## WEST PARK STORAGE TANK JSP14-14

Public hearing at the request of the City of Novi for Special Land Use Permit, Preliminary Site Plan and Stormwater Management Plan for a water storage reservoir and to replace pumps at the existing pump station located on the northeast corner of West Park and Twelve Mile Road. The 2.8 acre site will contain one expanded access off of West Park Drive, a six foot wrought iron security fence, and a new sidewalk along Twelve Mile Road.

# PLAN REVIEW CENTER REPORT

West Park Drive Water Storage Reservoir  
JSP14-14

WEST PARK DRIVE WATER STORAGE RESERVOIR & PUMPING STATION MODIFICATIONS PROPOSED SITE PLAN AND PIPE PROFILES  
DATE: 05/12/2025  
DRAWN BY: [REDACTED]  
CHECKED BY: [REDACTED]  
C8  
OF 25

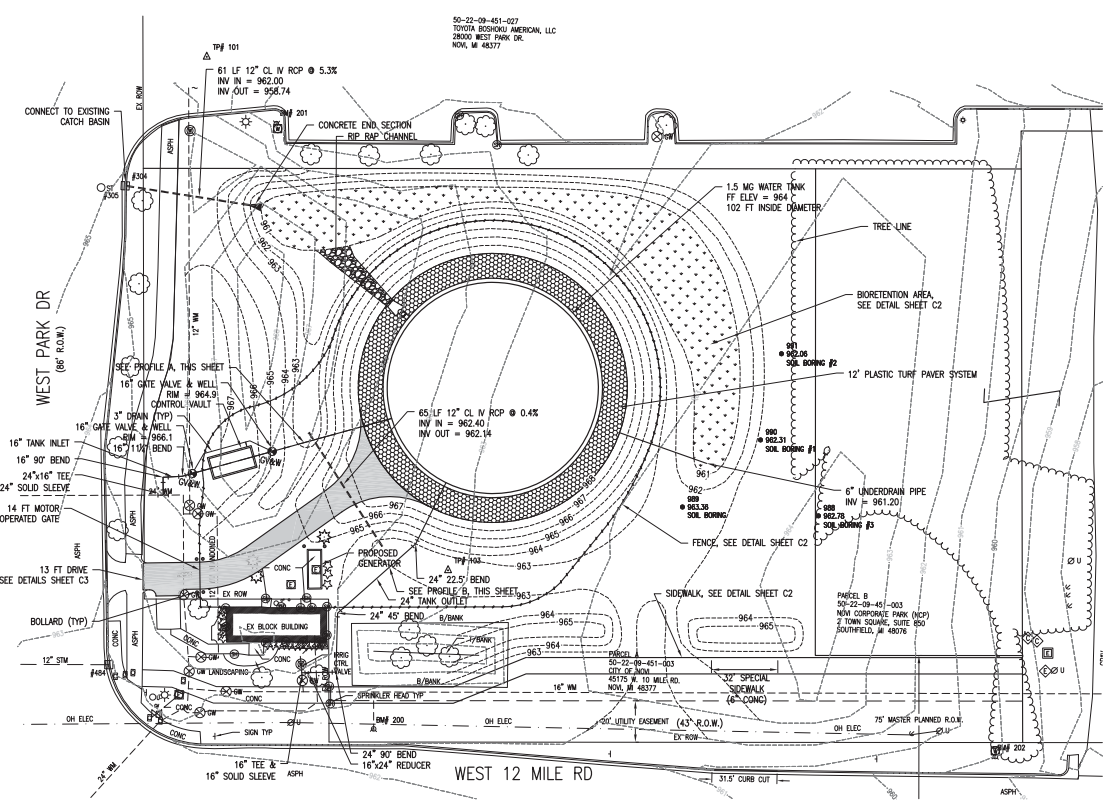
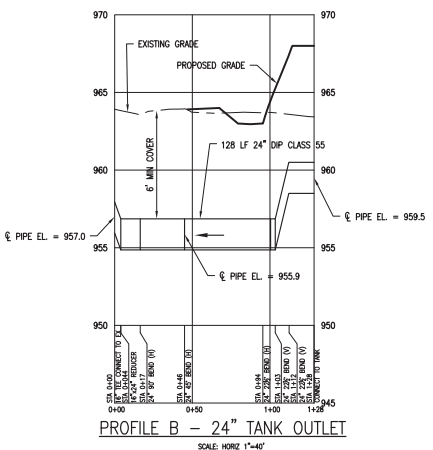
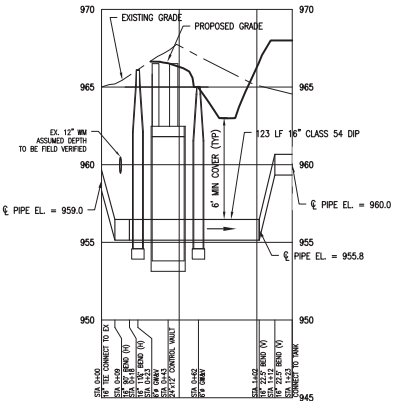
1. Please note that additional technical review regarding the Water Storage Tank details will be provided at a later date.
2. Provide a note on the plans that all work shall conform to the current City of Novi standards and specifications.
3. Consider relocating the tree plantings on West Park Drive outside of the existing water main easement.
4. Please note that the callout for the bioretention area on sheet C8 refers to a missing detail on sheet C2.

5. There appears to be an inconsistency between the elevations shown for storm manhole #305 (t/cast 985.07) and catch basin #304 (t/cast 964.84) which is approximately 10 feet away.
6. Consider providing a four (4) foot diameter inlet structure set at the high water elevation in lieu of the provided end section.
7. Provide a profile of the proposed storm sewer on the plan set.

8. The Storm Water Management Plan for this development shall be designed in accordance with the Storm Water Ordinance and Chapter 5 of the Engineering Design Manual.
  - a. Strongly consider providing the bioretention area basis of design on the plan set.
  - b. Consider providing undrain and aggregate storage in the proposed bioretention area if the soil borings report notes a low in-situ soil infiltration rate that may result in excessive or prolonged ponding.
9. An adequate maintenance access route to the basin outlet structure and any other pretreatment structures shall be provided (15 feet wide, maximum slope of 1V:5H). Verify the access route does not conflict with proposed landscaping.
  - a. Consider reinforcing the maintenance access route to accommodate heavy equipment.

10. Revise the side walk cross-section to indicate four (4) inches of 4000 psi concrete (8" thick through commercial/industrial drives) over six (6) inches of 21AA crushed limestone meeting MDOT gradation specifications. The stone base shall extend a minimum of 6" beyond the forms.
